PRODUCT SERVICE NOTIFICATION

PRODUCT SERVICE NOTIFICATION #: 10302012

SUBJECT: SOV3 Reserve Staging Loop with support washer. Manufacturer is requiring the washer be removed. At the next scheduled repack cycle, remove the washer from the bungee staging loop and tie a double over-hand knot as instructed below and reinstall.

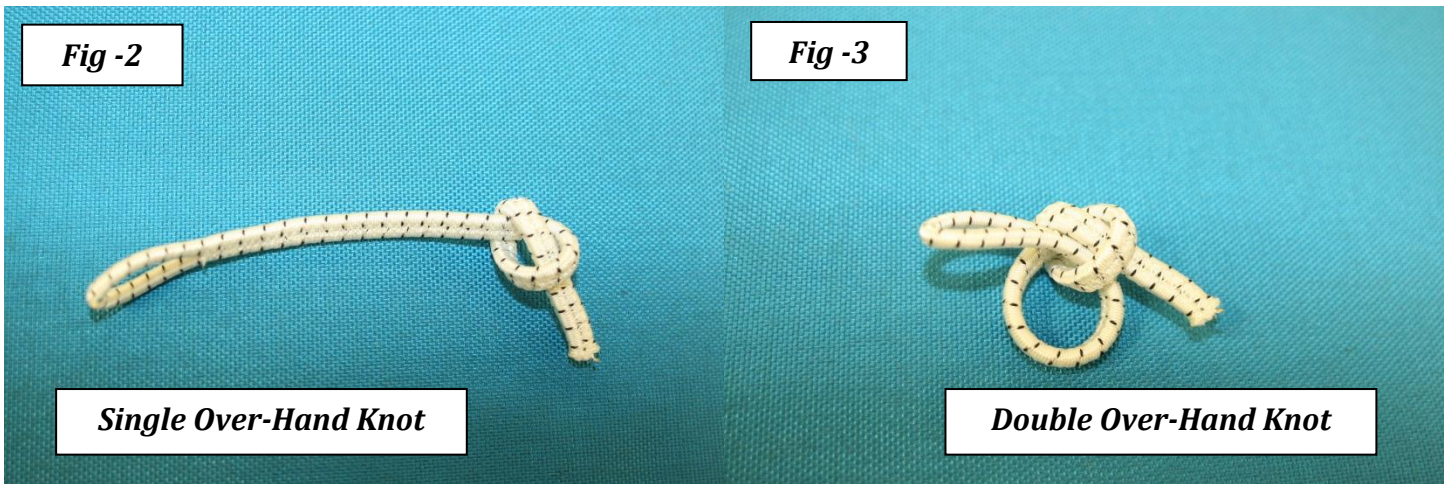
At the next scheduled inspection/repack cycle remove the support washer from the “**Reserve Staging Loop.**” (See **Fig-1**) Inspect the internal and external condition of the staging loop and replace it if any damage is found.

Tie a “Double Over-Hand Knot” at the prescribed location. The staging loop length should be 1-inch (25mm) shorter than the reserve closing loop. Mark the loop at the desired length. **Fig-2** shows a single over-hand knot. **Fig-3** shows the loop end passing one more time through to create the double over-hand knot. Pull the bungee loop as tight as possible. Longer staging loops are now available if needed.

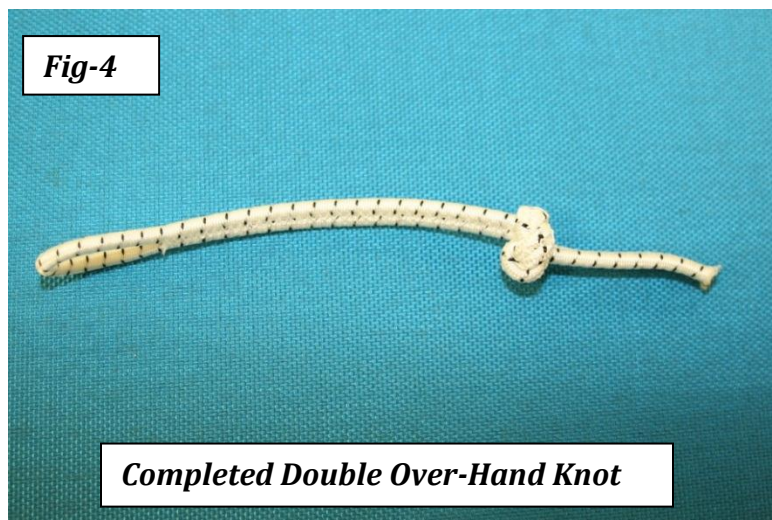
The finished “Double Over-Hand Knot” is shown in **Fig-4**. Reinstall the staging loop into the pack tray.
